Subject: River Bend Station – Unit 1
Docket No. 50-458
License No. NFP-47
Submittal of Revisions to Emergency Implementing Procedures

Submittal of Revision to the RBS Emergency Implementing Procedures

**LIST OF REVISED
EMERGENCY IMPLEMENTING PROCEDURES**

PROCEDURE NAME	TITLE	CURRENT REV.
EIP-2-002	Classification Actions	21
EIP-2-007	Protective Action Recommendation Guidelines	18
EIP-2-018	Technical Support Center	22
EIP-2-103	Emergency Equipment Inventory	16

PAR PROCESS

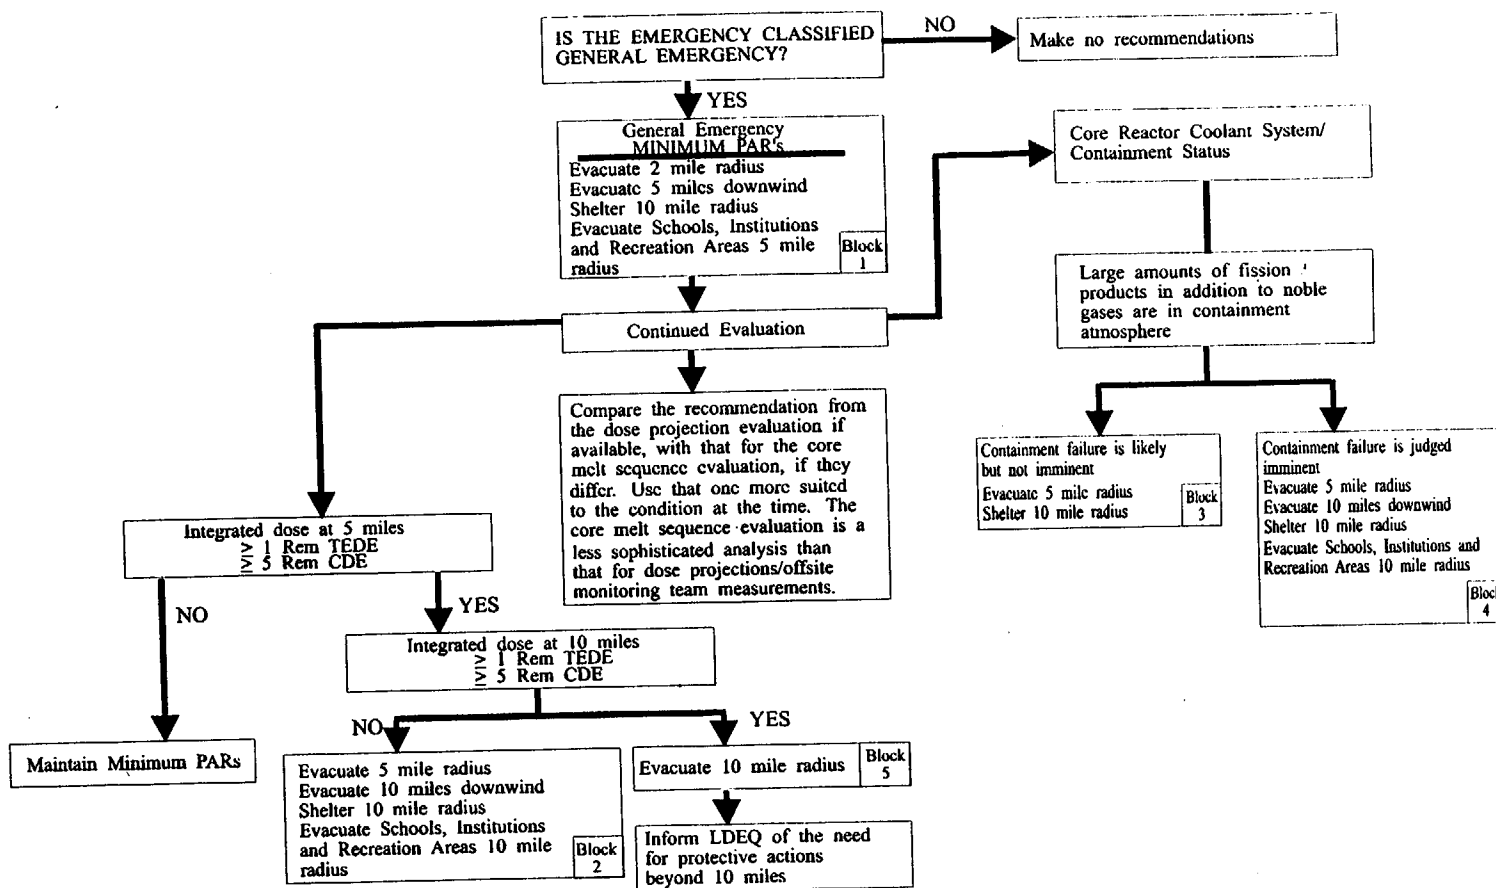
9. Steps 6.1.3 through 6.1.8- This information has been converted into the flowchart steps of Attachment 1. Additionally, specific details of contacting the local authorities within 5 minutes, etc. are contained in the Control Room Communicator's checklist in EIP-2-006 Notifications.
10. Step 6.1.9- Reworded text to state wind shifts which change the "scenario number may" trigger an increase in PARs to a higher level. "To determine the appropriate PAR, review the emergency scenario maps and the National Weather Service (NWS) forecast. In addition, if NWS indicates continued wind shifts" consider the following guidance...
11. Added Attachment 1 PAR Process.
12. Attachment 2- Changed LRPD to LDEQ due to their name change.
